THE BRIDGES - PARKSIDE PH 3

PRELIMINARY REVIEW DRAWING EDEN, WEBER , UTAH

FOR COUNTY SUBMITTAL X-X-XX

PARKSIDE PHASE 3

POND OUTLET
 THE BRIDGES - PRELIMINARY REVIEW
 PARKSIDE - PHASE 3
 EDEN, WEBER, UTAH

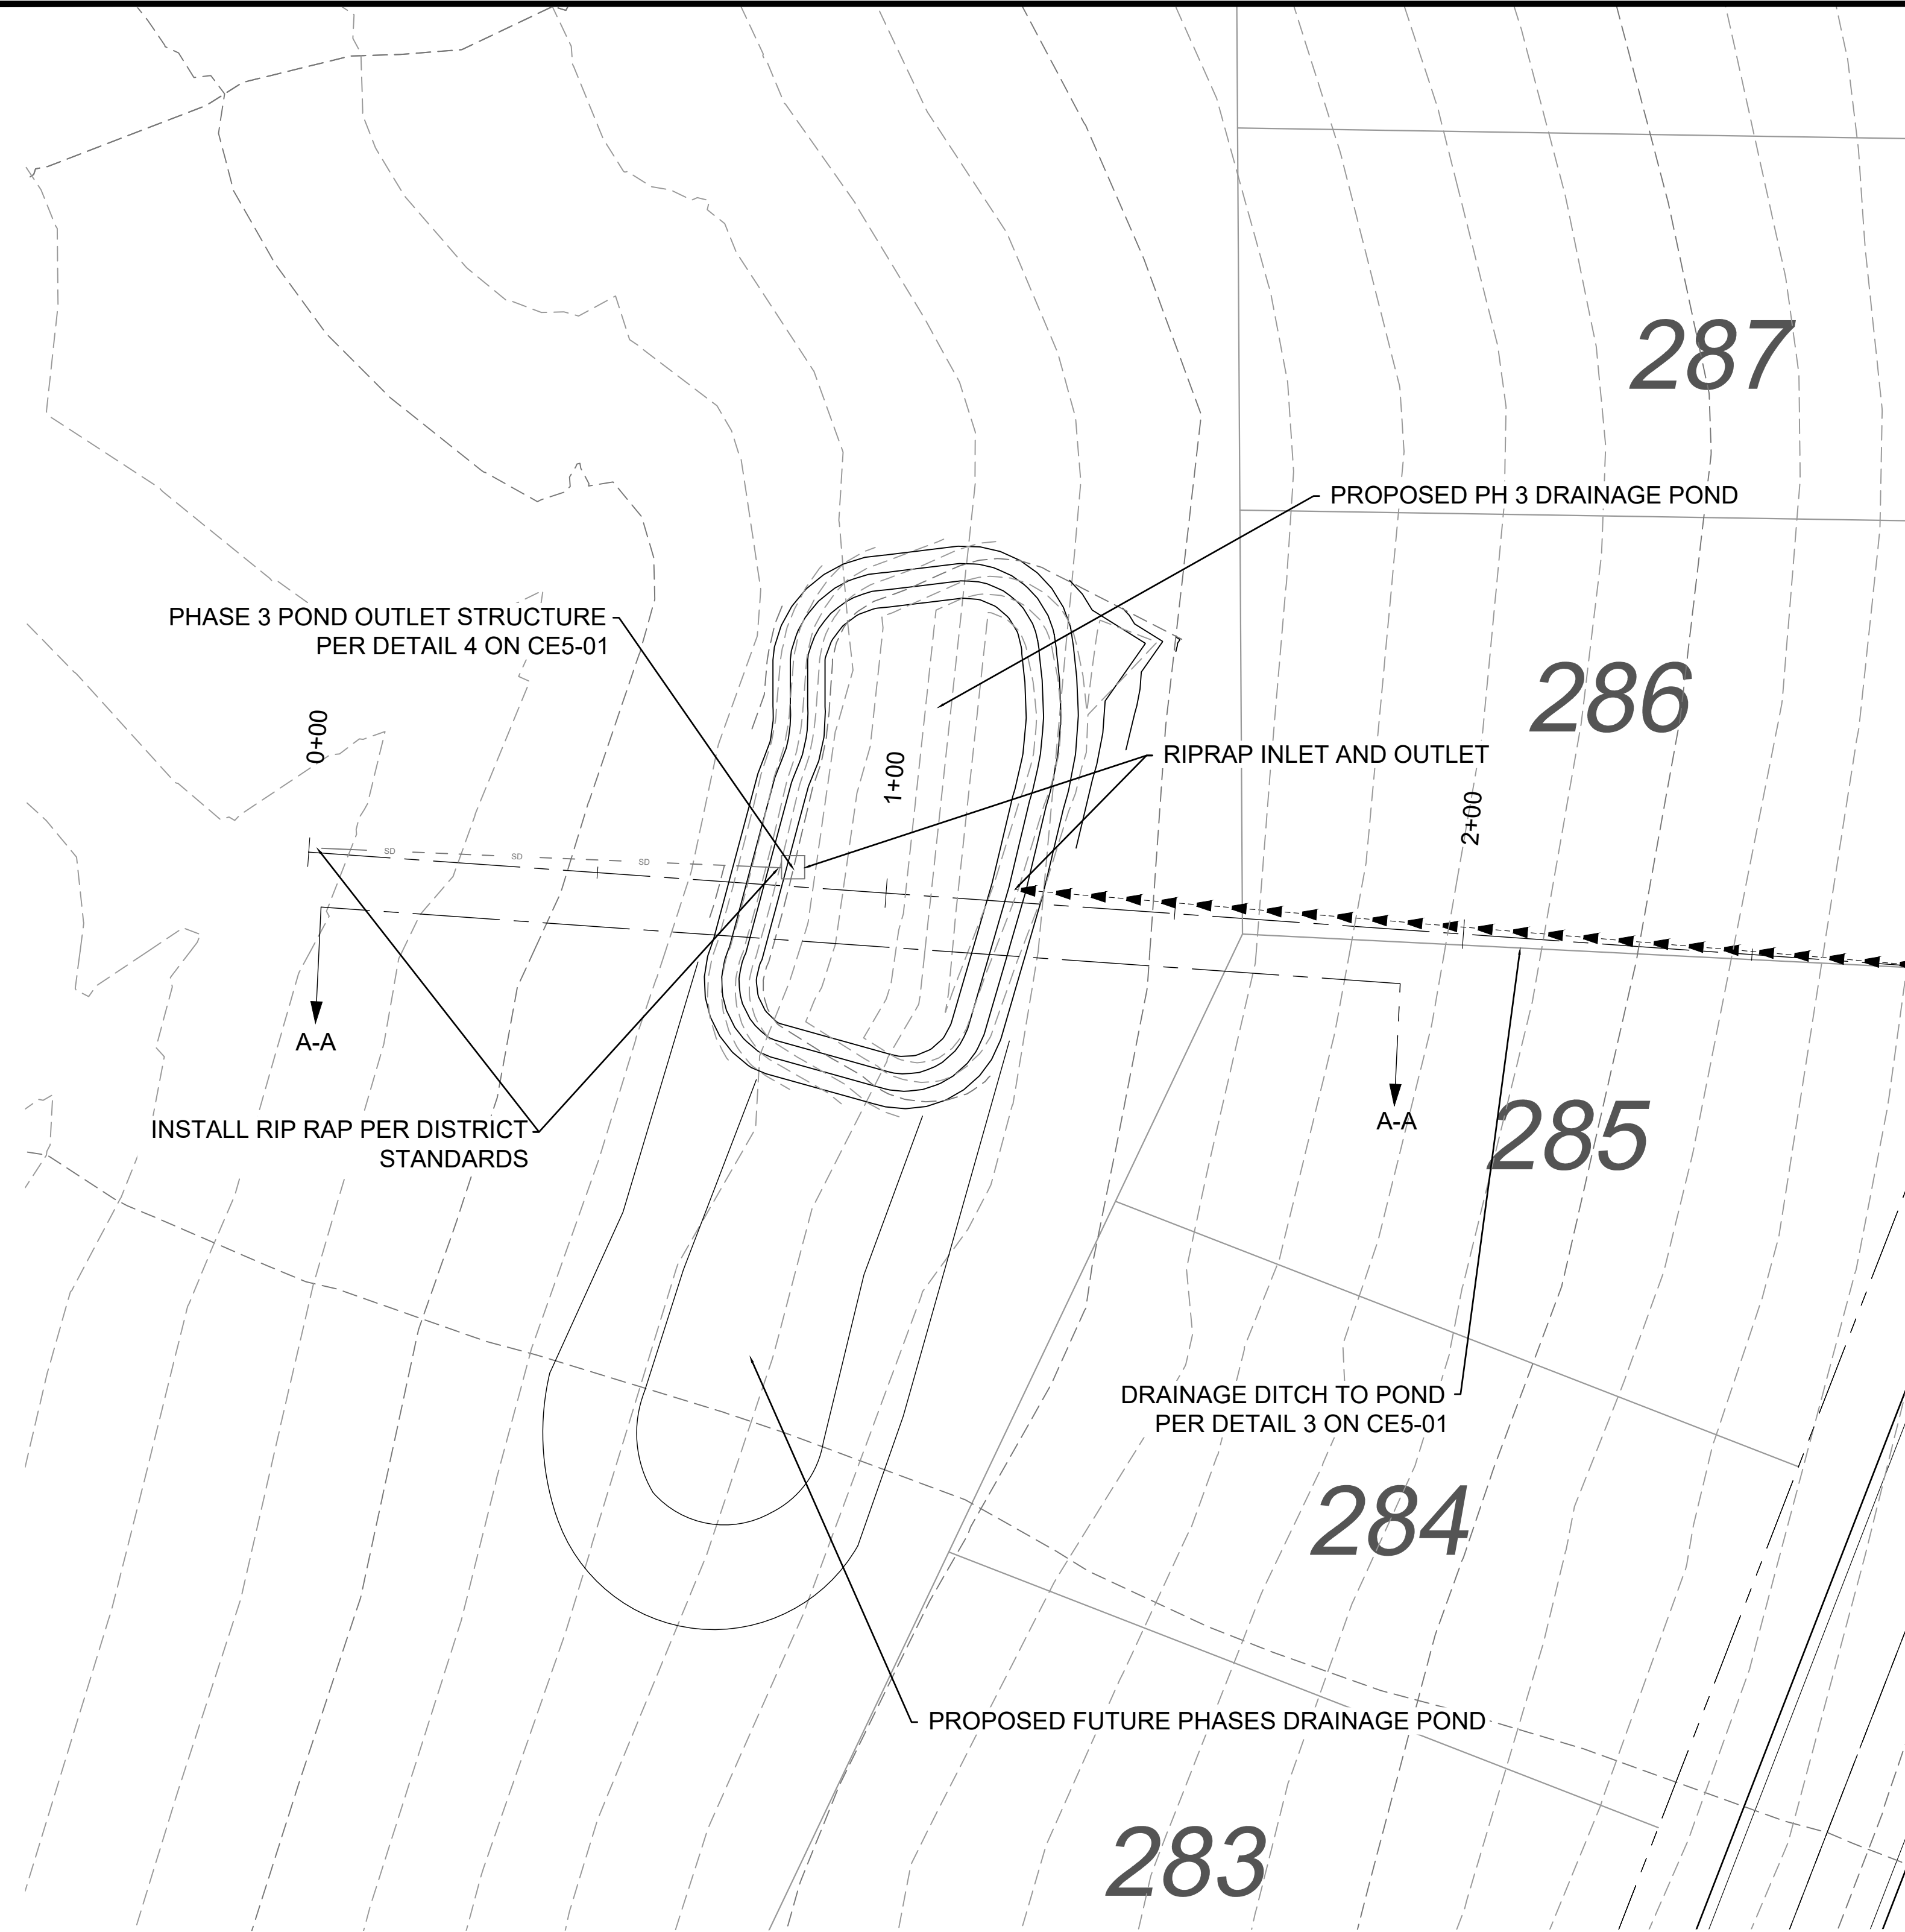
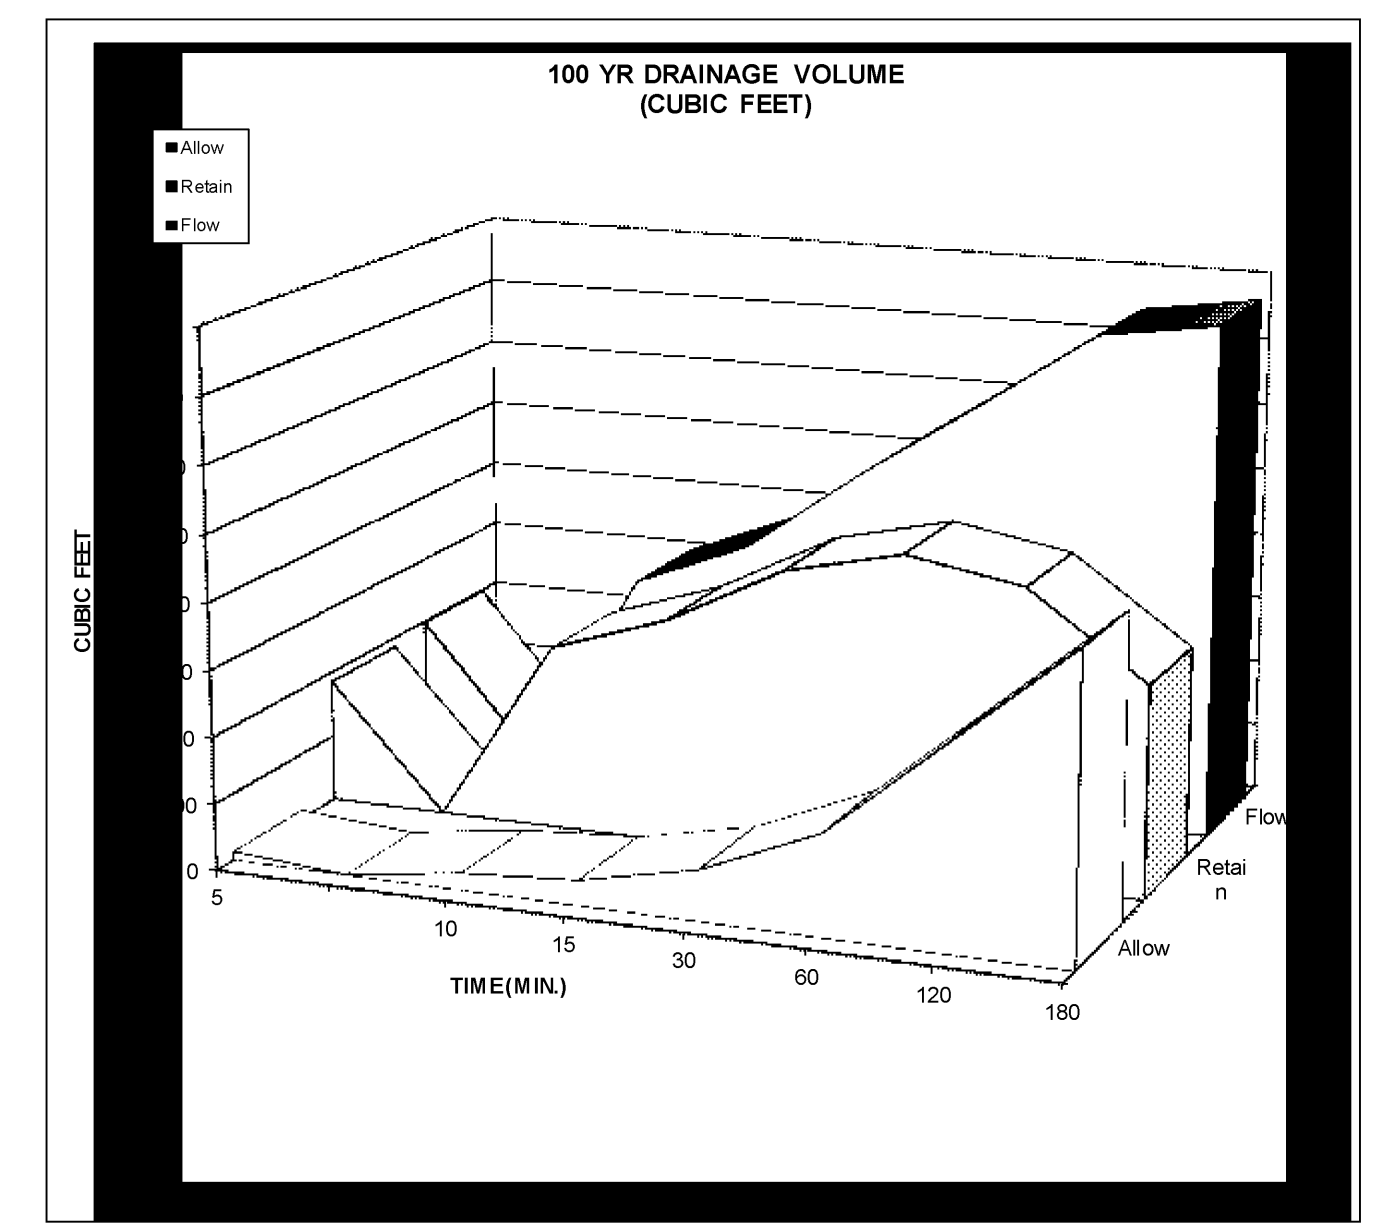
Needs to be 0.1cfs

ROAD 5 PROFILE

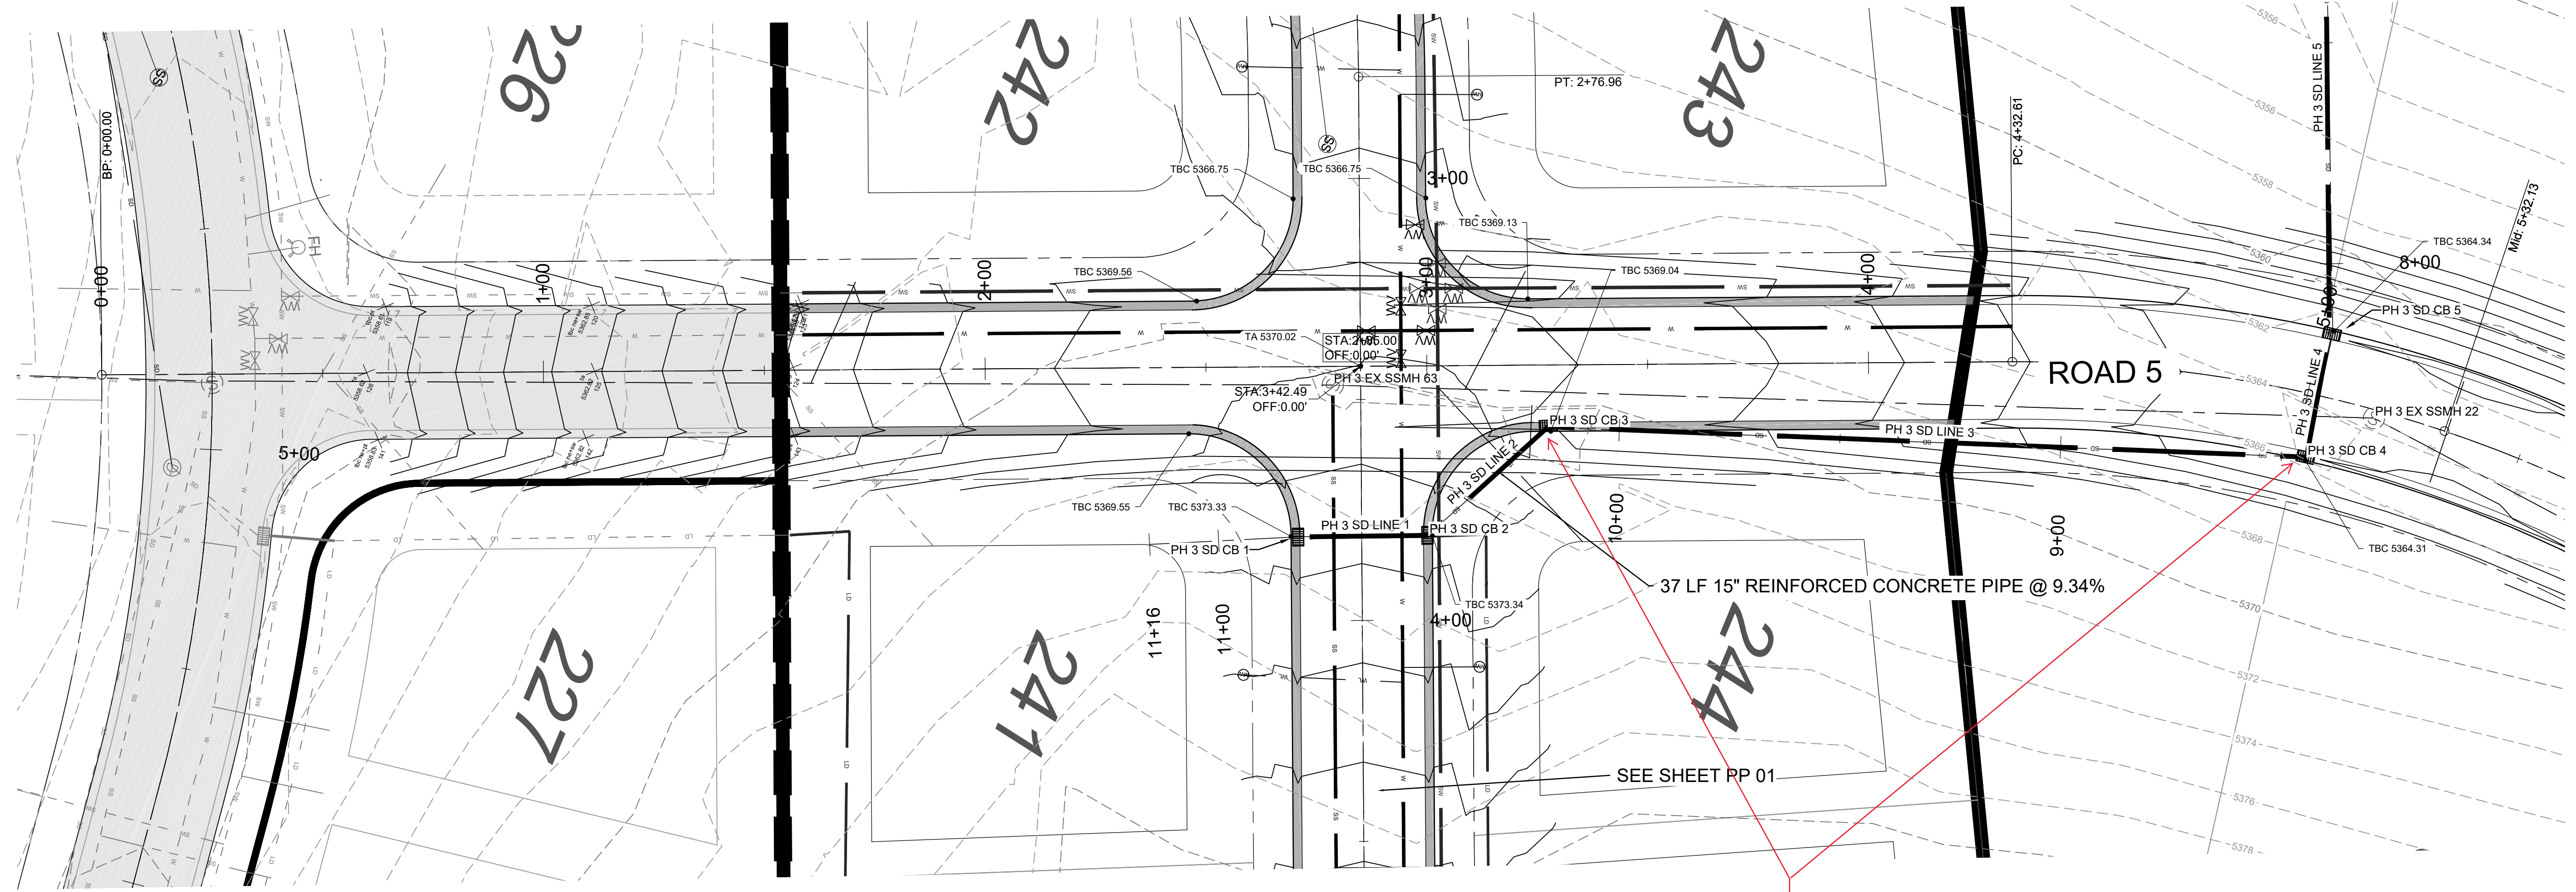
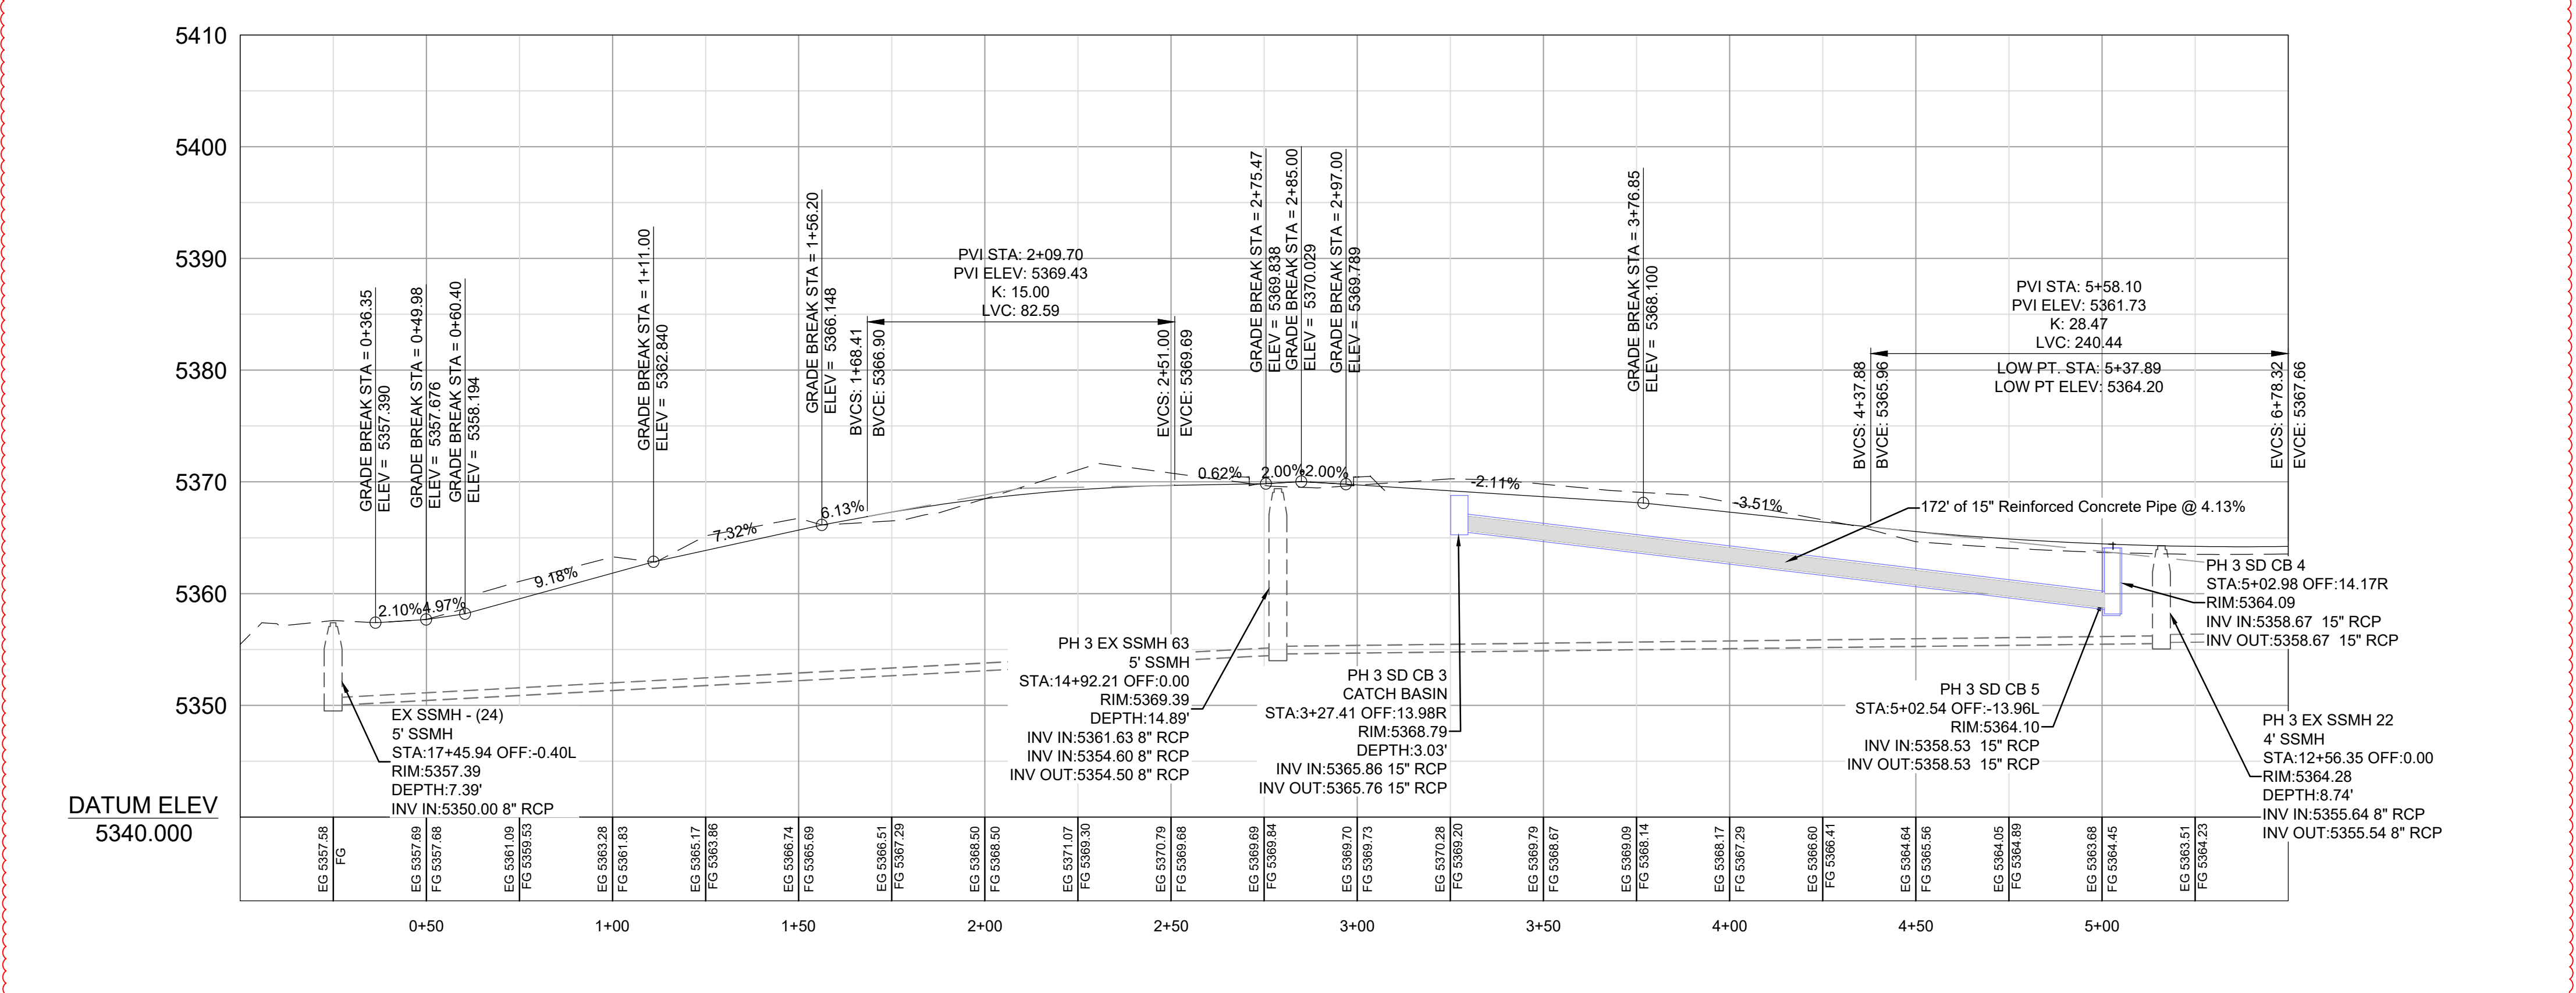
For future we will want to see these be combo boxes.
